# PEDESTRIAN / BICYCLE SAFETY REVIEW

SR 501 / Clearlake Road from Dixon Boulevard to Michigan Avenue

## **Pedestrian/Bicycle Safety Review Report for SR 501/Clearlake Road from Dixon Boulevard to Michigan Avenue**

## **Project Title: SR 501/Clearlake Road Pedestrian/Bicycle Safety Review**

Figure 25

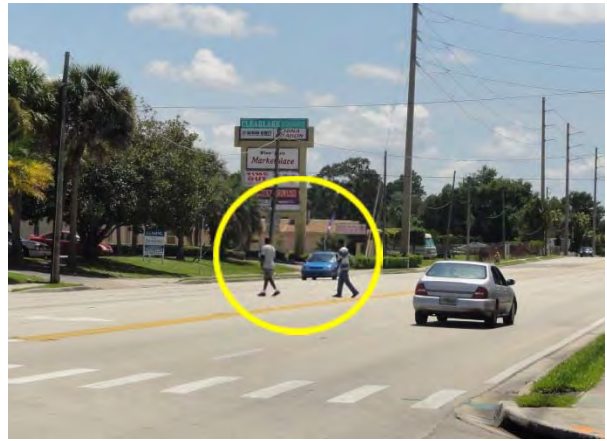
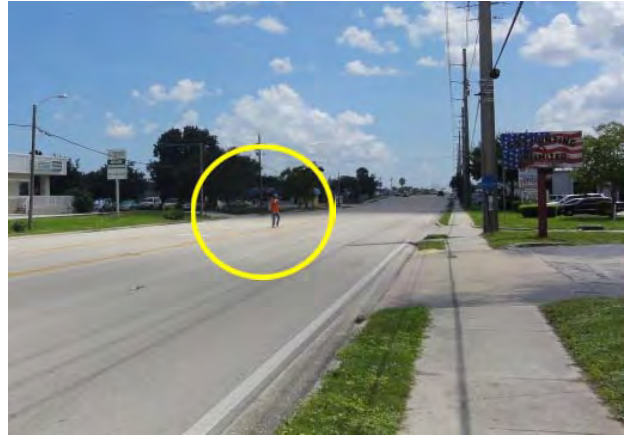
The field review team observed several instances where pedestrians chose to cross SR 501 at an unmarked and unsignalized location. As shown in **Figure 25** and **Figure 26** the pedestrians were observed crossing the south leg of the intersection of SR 501 and Dixon Boulevard less than 150 feet south of the marked signalized crosswalk location. In other instances, pedestrians were not as close to a signalized crosswalk and were observed crossing SR 501 and utilizing the center TWLTL as a pedestrian refuge (**Figure 27** and **Figure 28**).

Figure 38

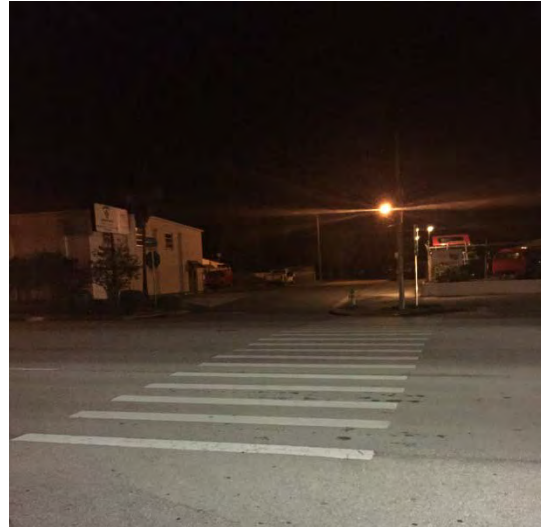
A mid-block crosswalk is present at the entrance to the BCCAEC, on the south side of the Clearlake Court intersection. The crosswalk is no longer attended by a crossing guard and would no longer be considered a school crossing once the school zone signs and pavement markings are removed. Pedestrian crossing activity was observed in the vicinity during the field review (**Figure 37**). **Figure 38** illustrates the lighting conditions at the crosswalk under night conditions. The fate of the mid-block crosswalk will need to be determined as part of the school zone removal (refer to **Issue #11: Overhead School Zone Structures**).

- Conduct a mid-block crossing study per Section 3.8 of the FDOT *Traffic Engineering Manual (TEM)* to evaluate if the crosswalk is still warranted based upon existing demands.
- Provide an active warning device, such as Rapid Rectangular Flashing Beacons (RRFB), at the crosswalk. RRFBs may also be used on the advance crosswalk signs per FHWA's interim approval memorandum. In-roadway warning lights activated by the RRFB may be considered as well. Standards and guidance from section 4N.02 in the *MUTCD* should be reviewed when considering in-roadway lights.
- Provide a median refuge island for pedestrians in the TWLTL.
- Install lighting on the crosswalk's west and east sides.
- Restripe the crosswalk with Special Emphasis Crosswalk markings consistent with sheet 10 of the FDOT Design Index 17346.

Figure 57

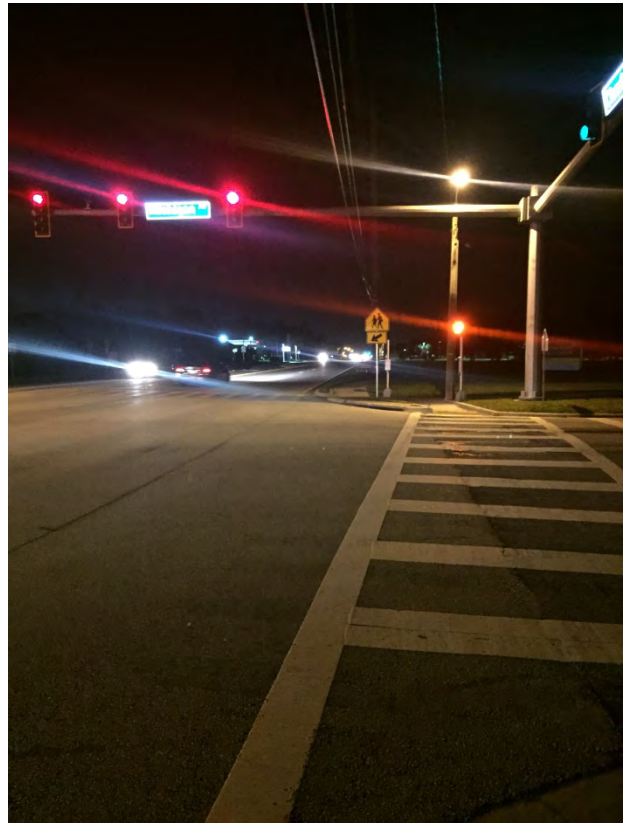
The intersection was recently upgraded from span wire to mast arms in addition to pedestrian facility upgrades. There was a light pole on the southwest corner of the intersection before the upgrades were made. Upon installation of the mast arm on the southwest corner, the light on that corner is blocked by the mast arm. **Figure 57** and **Figure 58** illustrate the location of the light pole and mast arm during daylight and nighttime conditions, respectively.
